Item Name: Floor Protector, Aft RH

DART AEROSPACE LTD		Work Order:	
Description: Floor Protector, Aft RH		Part Number:	D3281-4 <i>LD8</i>
Inspection Dwg: D3281	Rev: <i>D E</i>	Page 1 of 1

DRAWING NO. D3281	TITLE FLOOR PROTECTOR	REV. E	DART AEROSPACE LTD ENGINEERING ORDER		D.E.O. NO. D3281-E-1	SHEET NO. SHEET 1 OF 1	SCALE NTS
DRAWN <i>q</i>	CHECKED <i>R</i>	MFG. APPR. <i>OK</i>	APPROVED <i>TH</i>		DE APPR. <i>TH</i>		
DATE 10.02.24	DATE 10.02.25	DATE 10/02/25	DATE 10.02.25		DATE 10.02.25

ADD "D3281-xL08" MATERIAL OPTION. EXISTING PARTS TO BE IDENTIFIED AS "D3281-xL02"

D3281-1L08 FLOOR PROTECTOR (SHOWN)
D3281-2L08 FLOOR PRETECTOR (OPPOSITE)
 LOCATION OF ENGRAVING

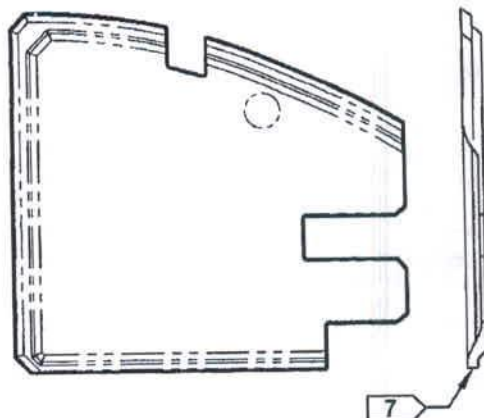
D3281-xL08 PARTS ARE EQUIVALENT TO THE RESPECTIVE "-x" PARTS EXCEPT AS DETAIL BELOW. THE MATERIAL, IDENTIFICATION, AND WEIGHT NOTES ARE AMENDED AS FOLLOWS:

- 2) MATERIAL: -xL02 = LEXAN F6006, BLACK No. 701, 0.093" THICK (MLEXS.093-F6006-02)
 -xL08 = LEXAN 90318 (PROTECT-A-GLAZE), 0.118 THICK, 112-CLEAR (MLEXS.118-90318-08)

- 7) IDENTIFICATION: IDENTIFY WITH DART P/N "D3281-xLxx" AND B/N "Bxxxxx" ON SMOOTH SIDE OF PART USING VIBRATING STYLUS.
 FOR -xL08 PARTS, LOCATE ENGRAVING ALONG PERIMETER OF PART AS SHOWN.

- 8) WEIGHT: D3281-1L02/-2L02 = 0.95 lb D3281-1L08/-2L08 = 1.13 lb
 D3281-1L02/-2L02 = 0.87 lb D3281-3L08/-4L08 = 1.05 lb
